ANN ARBOR HISTORIC DISTRICT COMMISSION

Staff Report

ADDRESS: 539 South Seventh Street, Application Number HDC24-0161

APPLICATION: The applicant seeks HDC approval to remove an accessory structure in the back yard and construct a garage with an accessory dwelling unit on the second floor.

Existing Garage / Accessory Structure - Built 1987

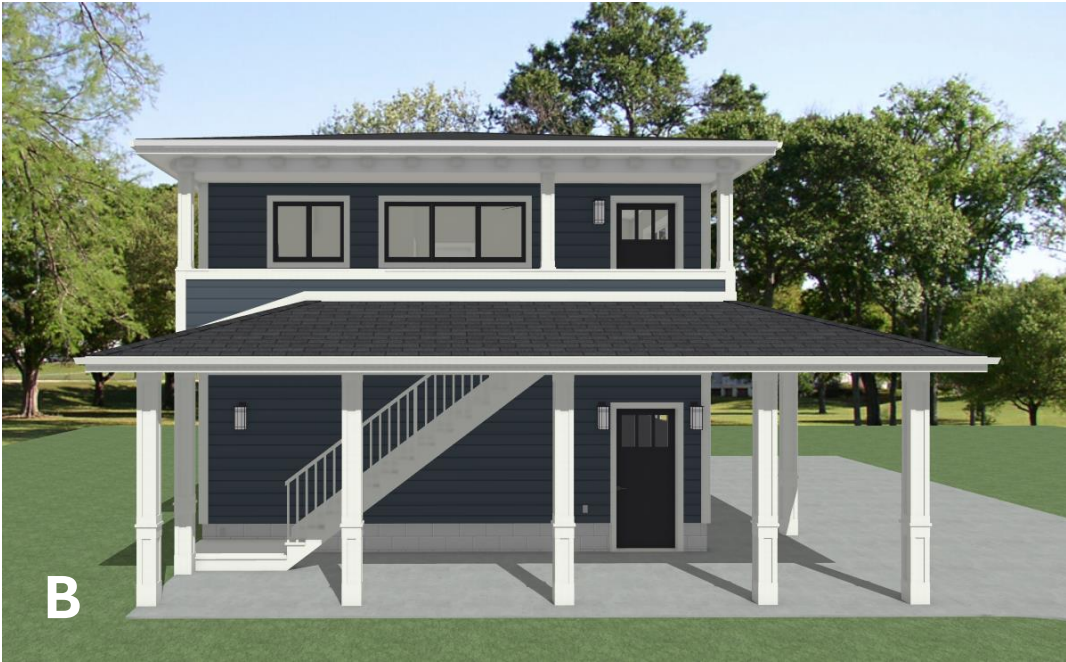
1. The current owner thought the playhouse was constructed in 1986, but permit records show that it was converted from a garage into a playhouse in that year. The garage was present during the period of significance. On aerial photos from 1947 it appears to be the same footprint but seems to have a gable roof instead of a flat or low-sloped roof. It is possible that the front gable wall was left intact when the roof style was changed to what's there today. Another theory is that the roof shape is original but the front wall was built up to look like a gable front. In either case, any garage doors were removed and a street-facing window and child-height door replaced them. Another window opening facing south is probably also an enlargement from this time. A new concrete floor was poured in 1986, and at least the south elevation has new siding. Staff does not know if the interior walls are finished with drywall.

While the structure was previously a garage and has the same footprint, staff believes the alterations have compromised its architectural integrity (as a garage). Only its massing is consistent with its garage use (and that massing may have been altered if it originally had a gable roof). It is also no longer convertible back to a garage since there is no longer a driveway on the north side of the house and an addition built on the house prevents moving the driveway back. Because of the changes to the openings, roof and driveway, staff believes the playhouse has lost its integrity and is a non-contributing structure.

A2.0

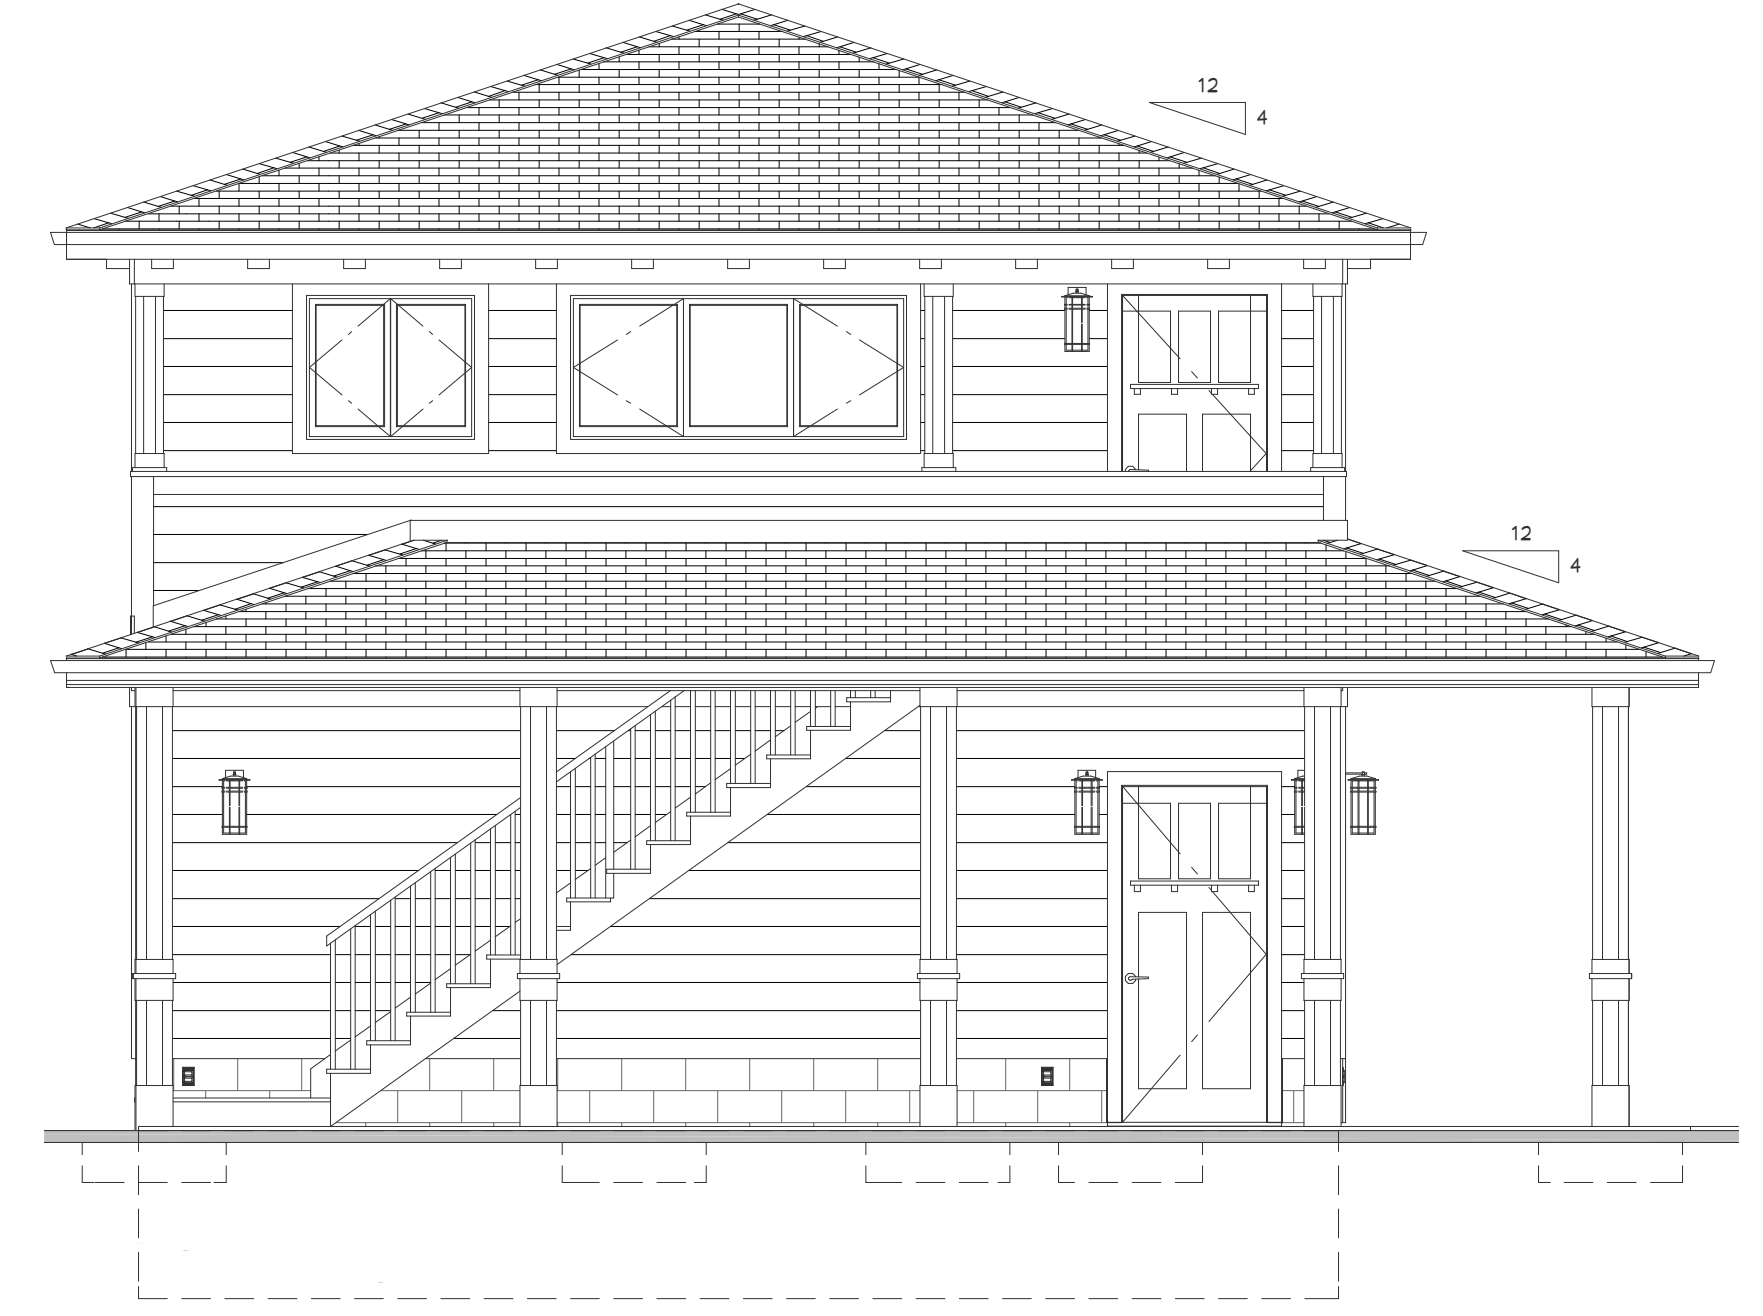
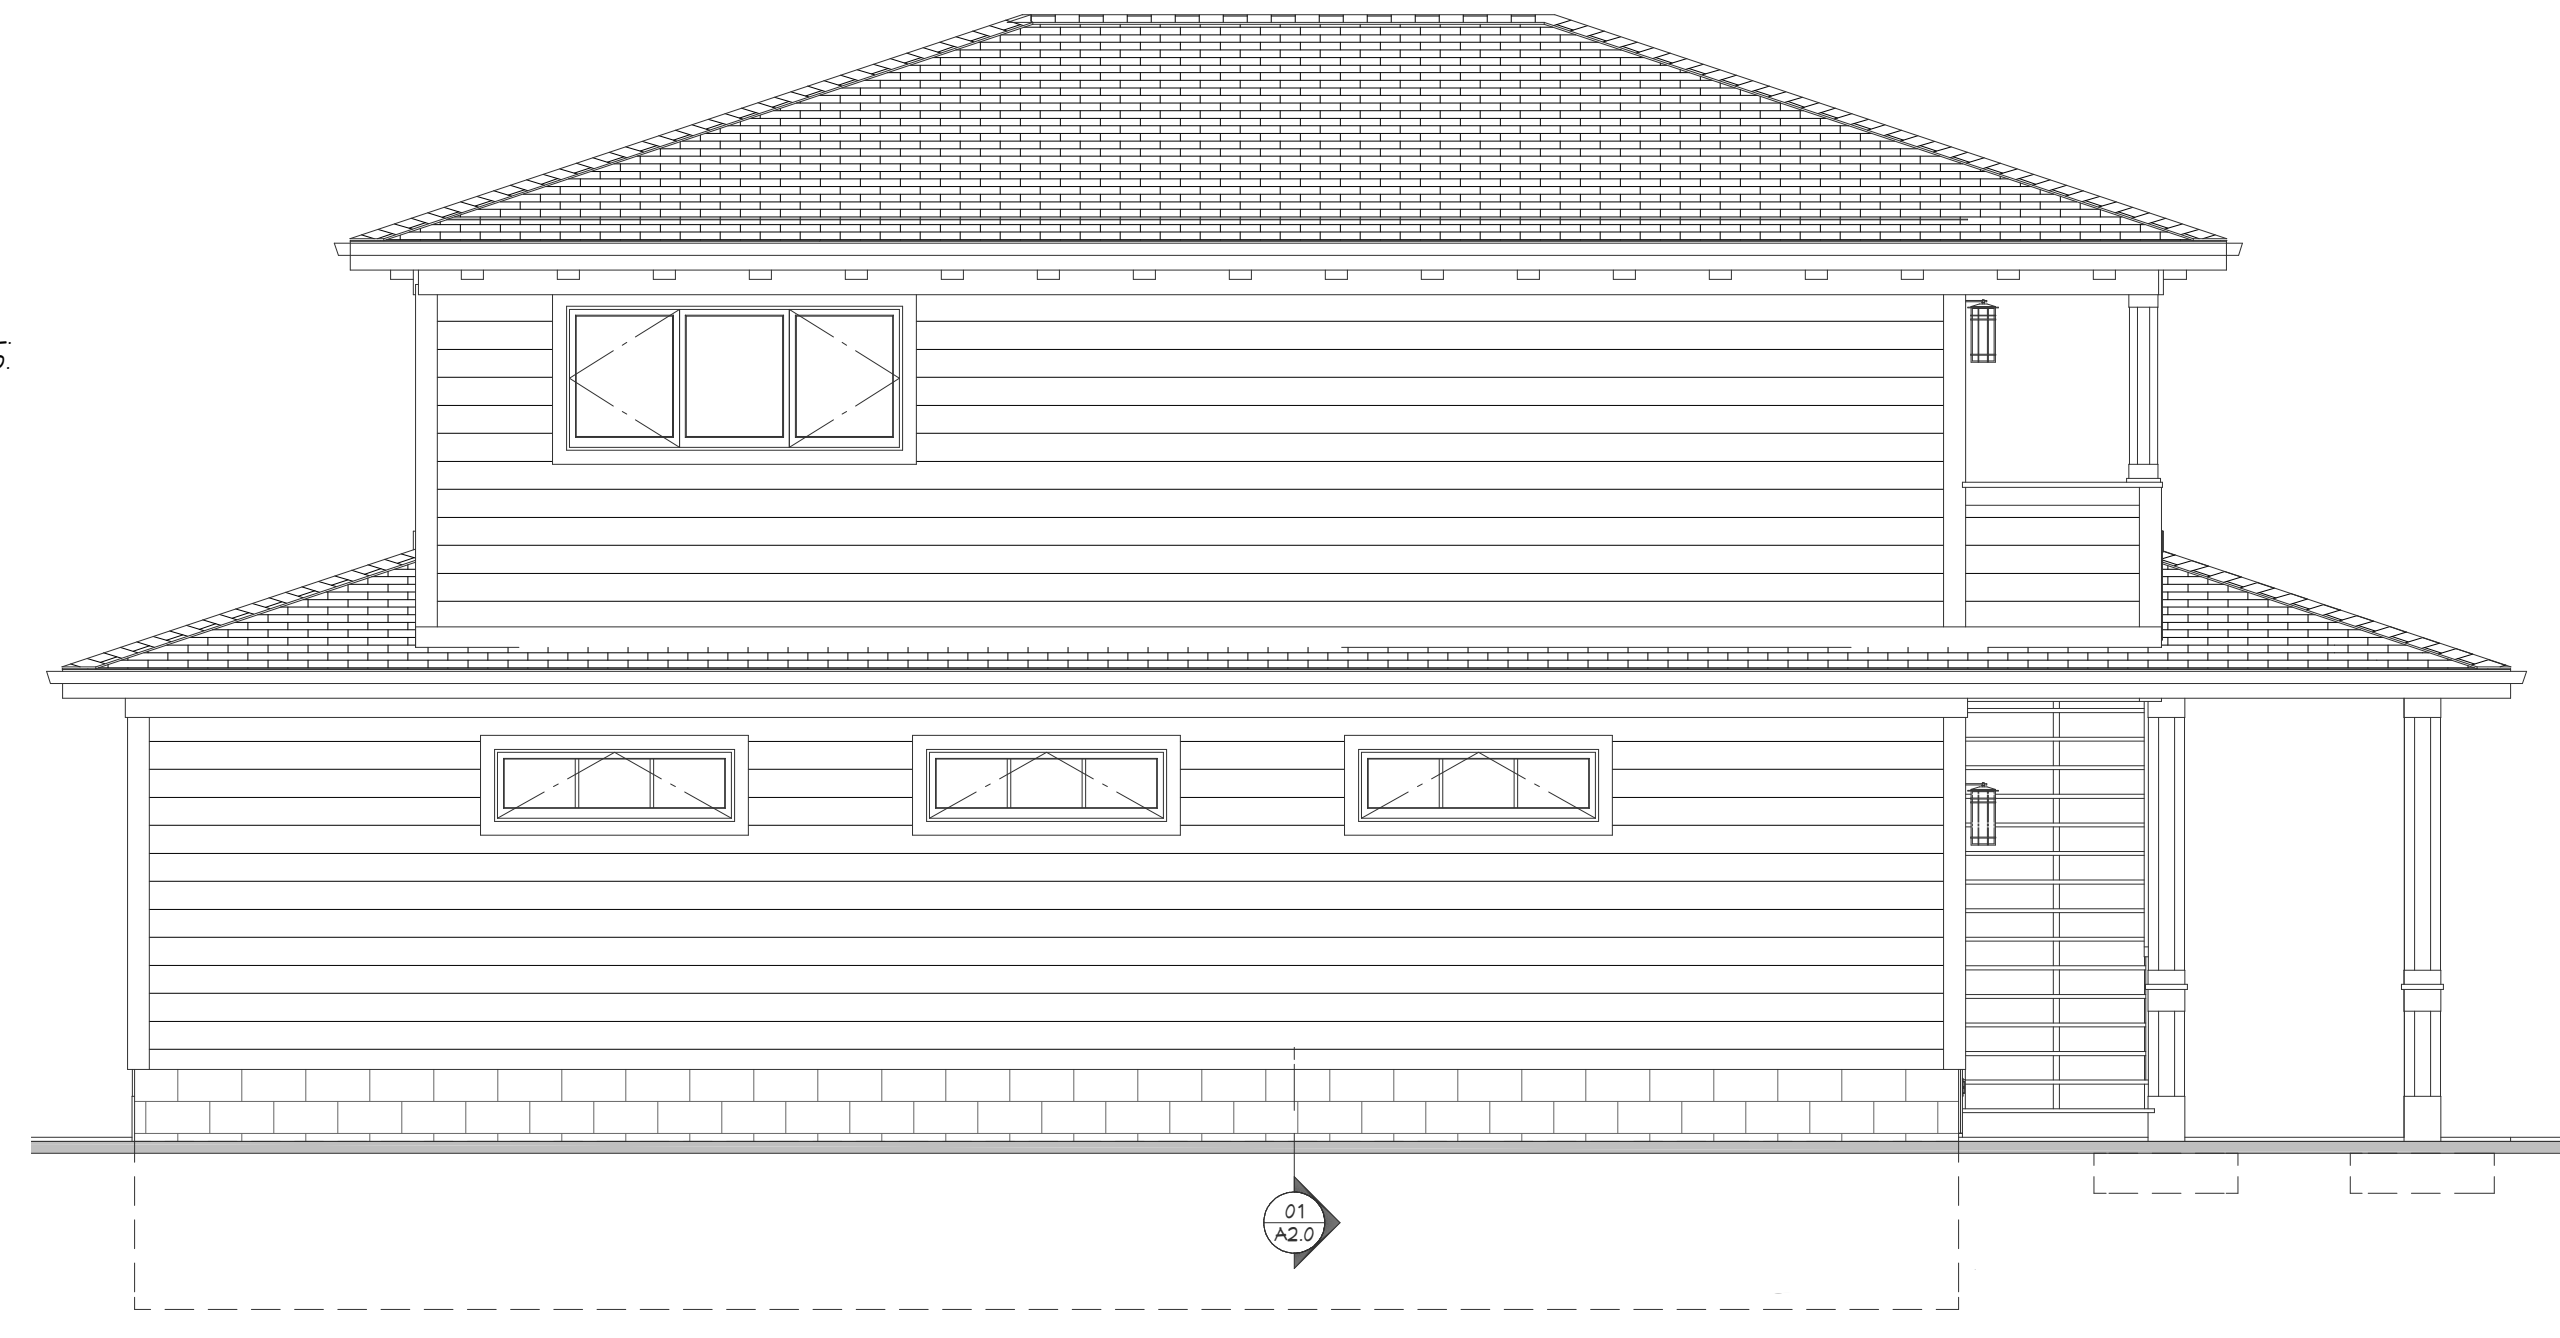
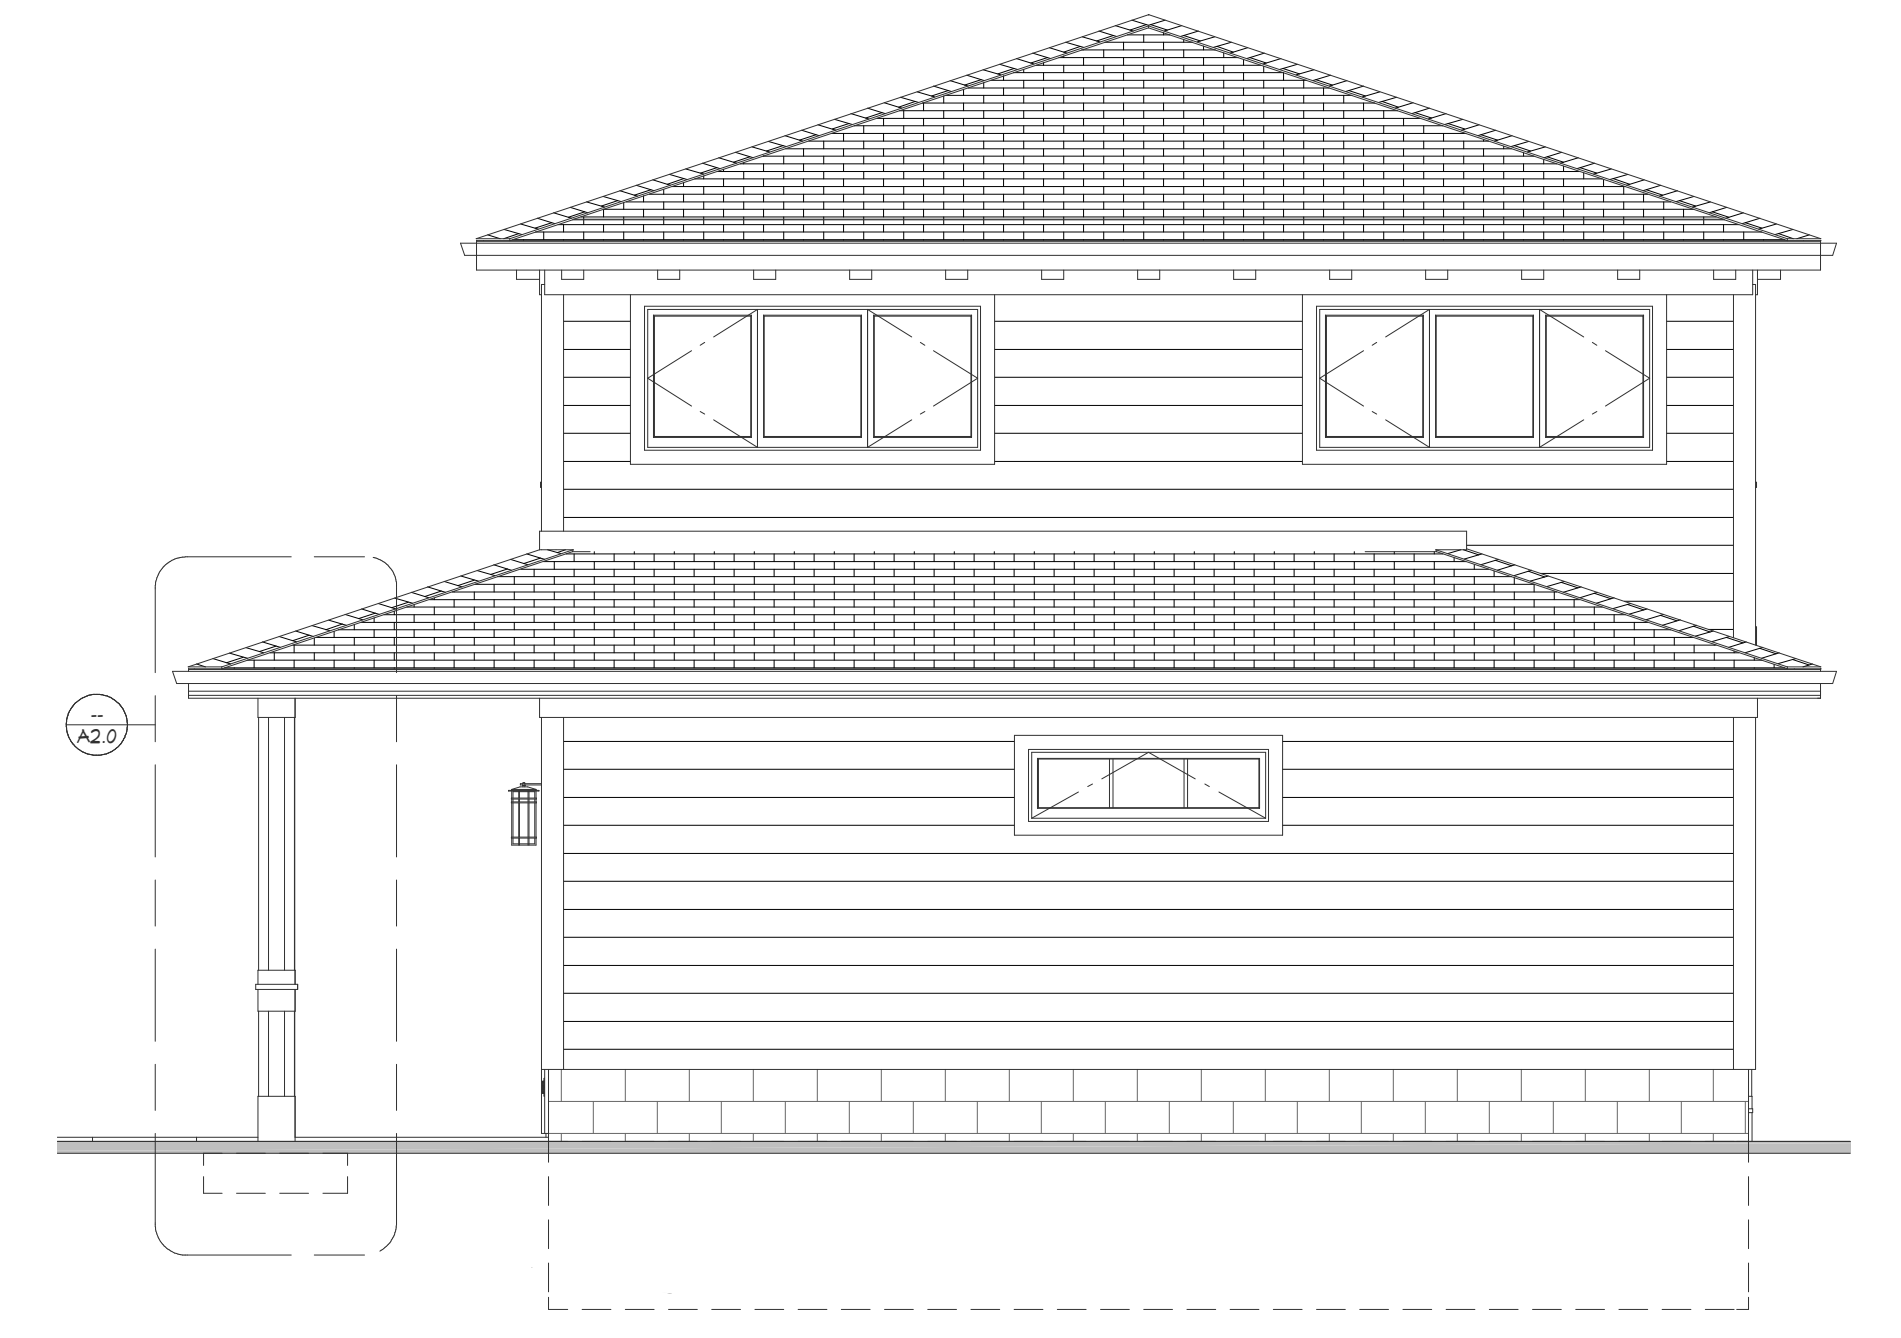
2. The owner proposes to remove the playhouse and build a new garage with an upper floor accessory dwelling unit. The footprint of the new structure is 25' wide (facing west toward the street) and 38' deep. The upper floor apartment does not reach all the way to the back of the first floor and is 25' wide by 32' deep. The hip roof overhangs a covered stair to the second floor and porch for an additional 4'. The attachments state that the hip roof mimics the roof of the house's front porch. Eaves are 1 ½' deep. Around the west and south elevations is a 7' 6" first-story roof overhang that forms a sort of wrap-around covered gallery. Overall the building is 21' to the midpoint of the gable roof (the maximum height allowed for accessory structures as measured by the zoning ordinance), or around 23' to the ridge.

4. Siding is cementitious lap. Windows are Andersen 100 series made of Fibrex composite material. Exterior door materials are not specified but wood, fiberglass or steel would all be appropriate. The design is three ¼- height lites over panels. The garage doors have six lites over panels. Columns supporting the gallery are 8"x8" wood with panels.

5. Overall, the design of the accessory structure has many horizontal elements – the hip roof, wrap around gallery, and horizontal casement and awning windows. While the design guidelines suggest copying the pitch of the house's roof, this design instead uses the front porch roof as a model. This ADU is the maximum size allowed by code, and the structure is the maximum allowed height.

6. This project is the largest accessory structure the HDC has reviewed in staff's memory, but warrants consideration of its merits as well as challenges. The building is large, and tall. It is set more than 70' from the sidewalk. The building front is in the same location as the playhouse front (and aligned with garages on lots on both sides), and the new structure has a larger side setback. This puts it squarely behind, and as hidden as possible by, the house. The design is modern and materials are compatible with the house. The roof does not meet the design guideline that recommends the pitch match that of the house. The building is deeper than it is wide, which is appropriate. Staff has concerns that the gallery wrapping two sides of the garage adds to its bulk and makes the large structure appear even bigger, especially on the garage side.
